## 2014 - 2016 Corvette: Service Bulletin: #17-NA-278: Convertible Top Creak or Snap Noise While Driving

### #17-NA-278: Convertible Top Creak or Snap Noise While Driving - (Aug 29, 2017)

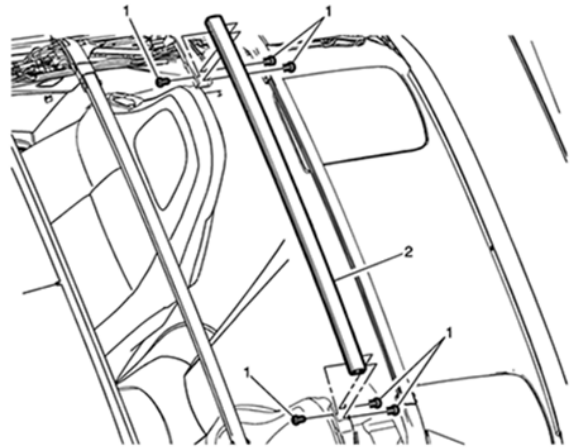
<i>Involved Region or Country</i>	North America, Japan, Europe, Middle East, Russia
<i>Condition</i>	Some customers may comment on hearing a creak or snapping noise from the convertible top while driving their vehicle. The noise may be loudest when the vehicle has sat in the sun for a length of time.
<i>Cause</i>

The cause of the condition may be that the fasteners (1) at the ends of the #3 Bow (2) may have lost torque.

Following the Service Procedure below, remove the original smaller screws and install the new larger M6 screws referenced in the Part Table.

1. Starting on either side, replace the current M5 retaining screws with the new M6 self threading screws.

Tighten the screws to 3 Y (27 lb in).
